La Jolla Shores Planned District Advisory Board (LJSPDAB) APPLICANT PROJECT INFORMATION FORM

- Project Tracking System (PTS) Number/Accela "PRJ" Number and Project Name (only submitted projects to the Development Services Department can be heard as action items):
PRJ-1085883

- Address and APN(s):
8303 LA JOLLA SHORES DRIVE, LA JOLLA, CA 92037
APN(s): 346-250-0800, 346-250-0900, 346-250-1000
- Project contact name, phone, e-mail:
ANDY FOTSCH - WILL AND FOTSCH ARCHITECTS
858-224-2486
PERMITS@WILLANDFOTSCH.COM

- Project description:
 - **SITE DEVELOPMENT/COASTAL DEVELOPMENT/NEIGHBORHOOD DEVELOPMENT PLANS**
 - 1 CONSOLIDATED LOT SPLIT INTO 6 INDIVIDUAL LOTS
 - EACH LOT TO CONSIST OF 1 SINGLE FAMILY DWELLING

PROPOSED GRADING
& DRAINAGE PLAN
C-2
LOT 1

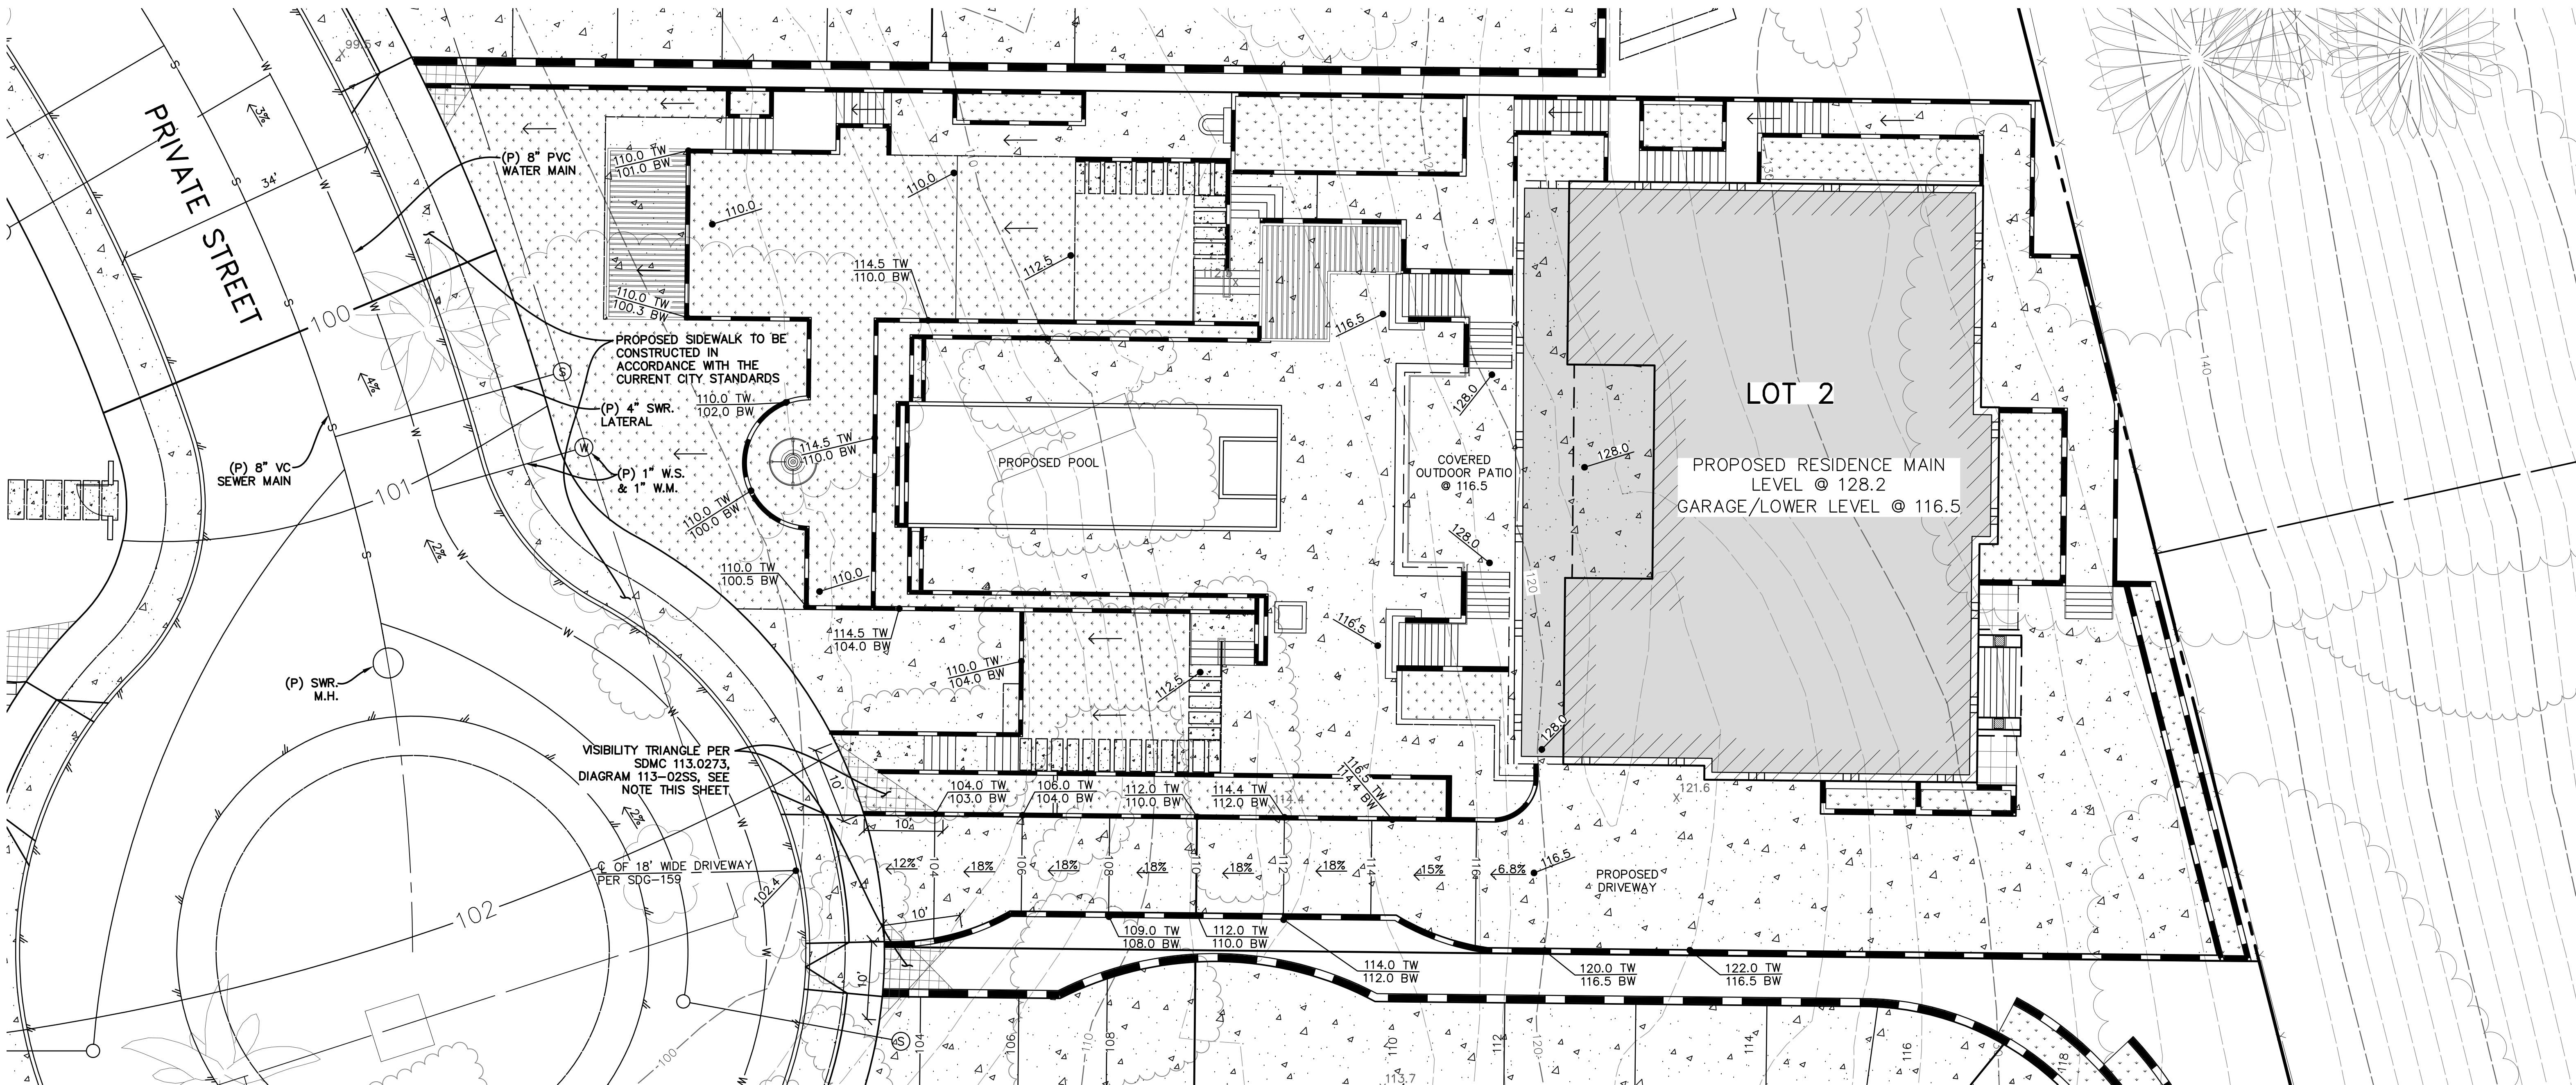
- The transitions for Lot 1 shall not exceed 7.5% grade at the top and bottom of the ramp with a gradient of 15% as shown on Sheet C-2.
 - The transitions for Lot 2 shall not exceed 9% grade at the top and bottom of the ramp with a gradient of 18% as shown on Sheet C-3.
 - The transitions for Lot 3 shall not exceed 8.9% grade at the top and bottom of the ramp with a gradient of 17.8% and shall not exceed 8% grade at the top and bottom of the ramp with a gradient of 16% as shown on Sheet C-4.
- Please revise Sheets C-2, C-3, and C-4 accordingly and show the length of these transitions as 8 feet for the first and last of the driveway ramp. (2nd Request)

PROPOSED GRADING & DRAINAGE PLAN
C-7
LOT 6

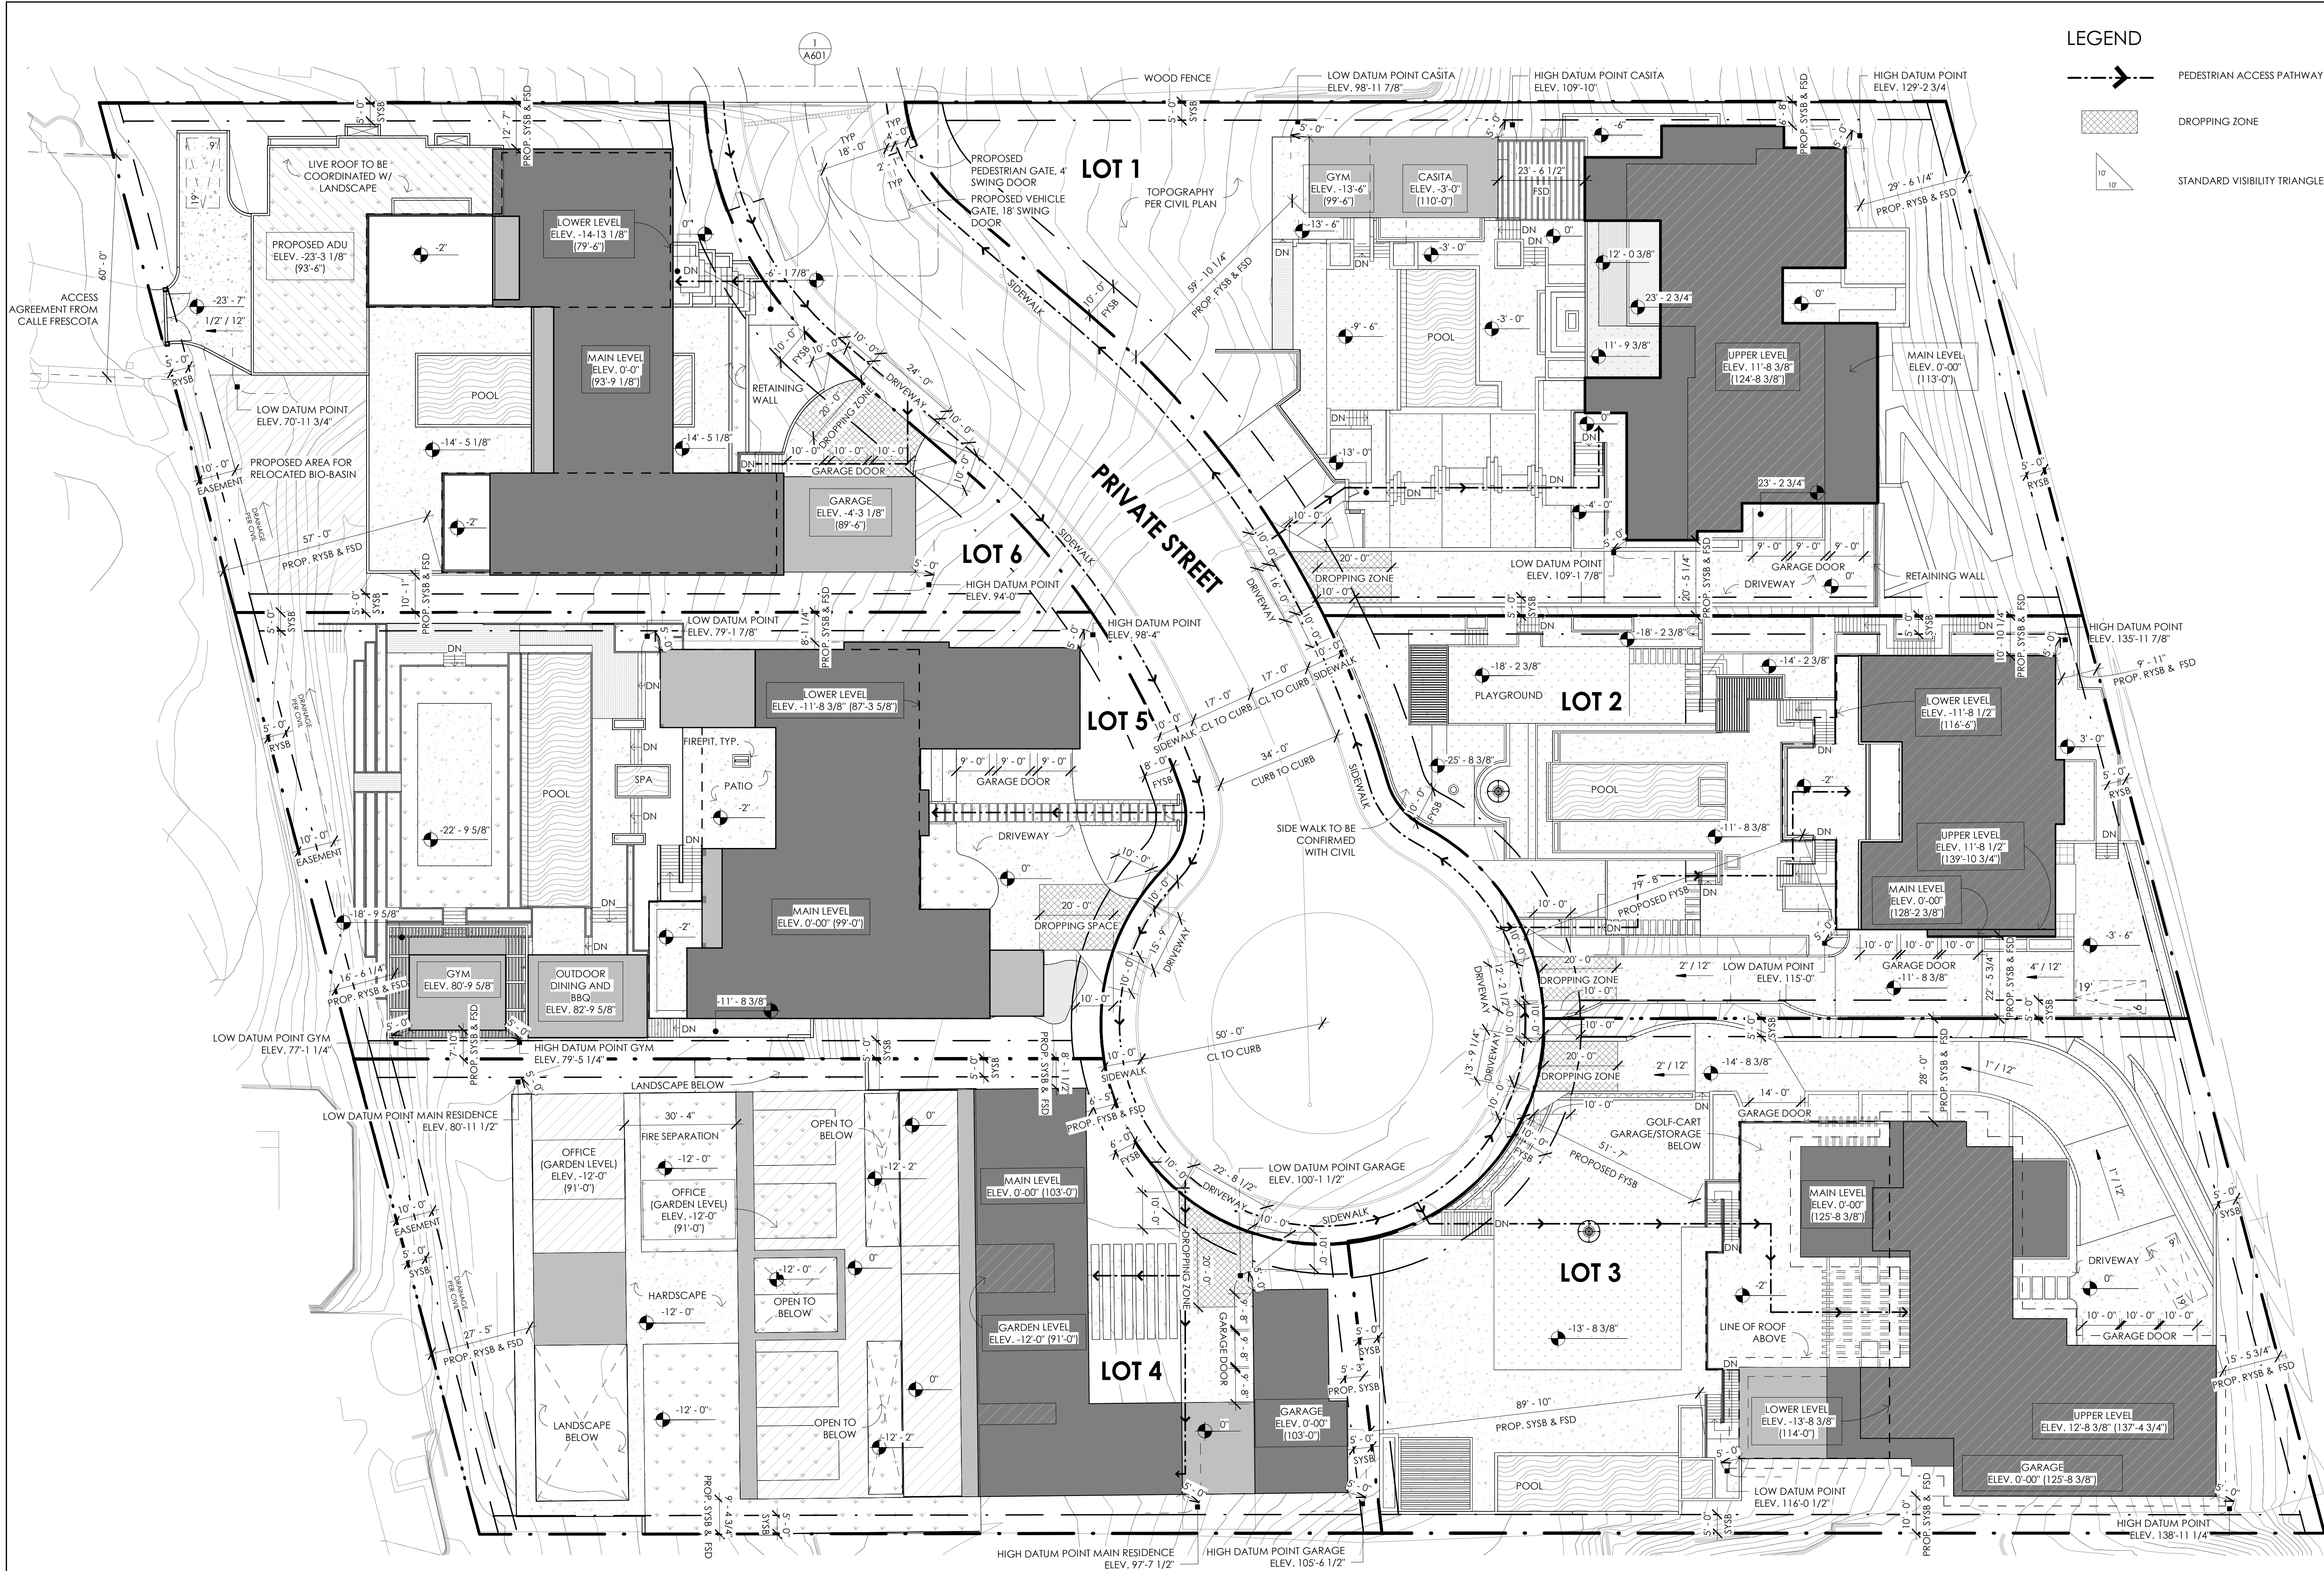
Per applicant response to Issue #102, driveway length of at least 20 feet for Lot 1, 2, 3, 4, and 5. Sheet C-7 shows a driveway length that appears to be less than 20 feet for Lot 6; please dimension the driveway length for Lot 6 per SDMC Section 142.0560(j)(4) and Diagram 142-05A. (2nd Request)

A001
LOT 1 - SITE PLAN

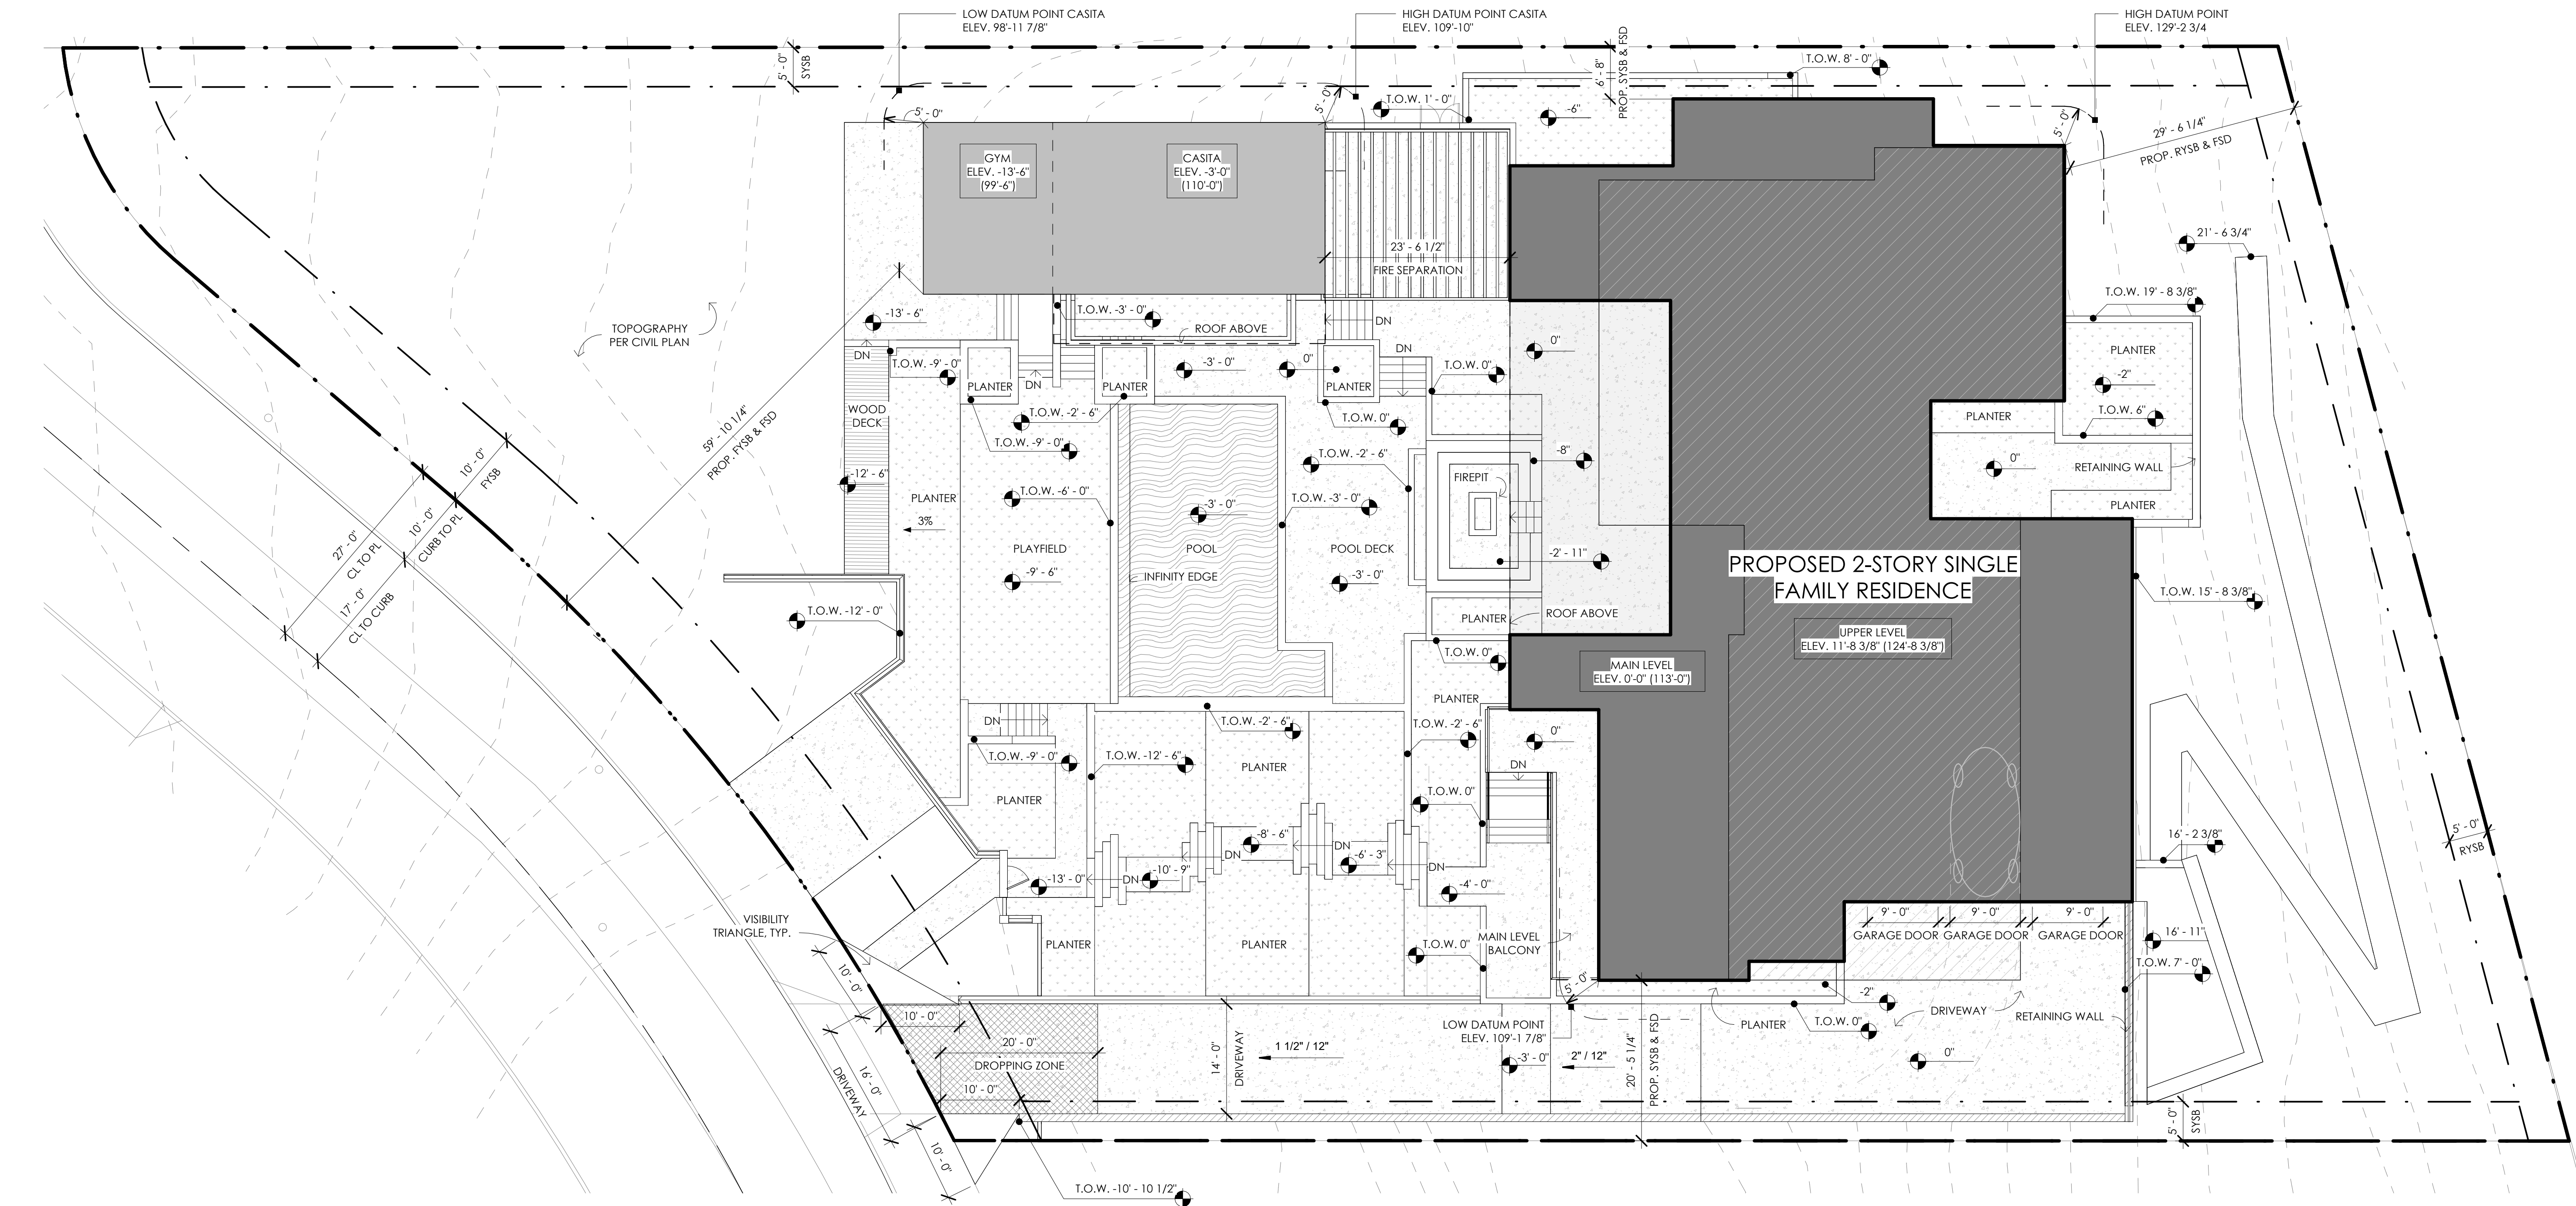
Per 142.0510(e)(1), off-street parking spaces shall not be located in any required front or street side yard setback. Sheets A000, A001, A002, and A204 show vehicular parking spaces located in the front and side yard setback for Lots 1 and 2. Please remove any parking spaces within the setbacks. Revise the parking count and parking table on Sheet TS002 accordingly.
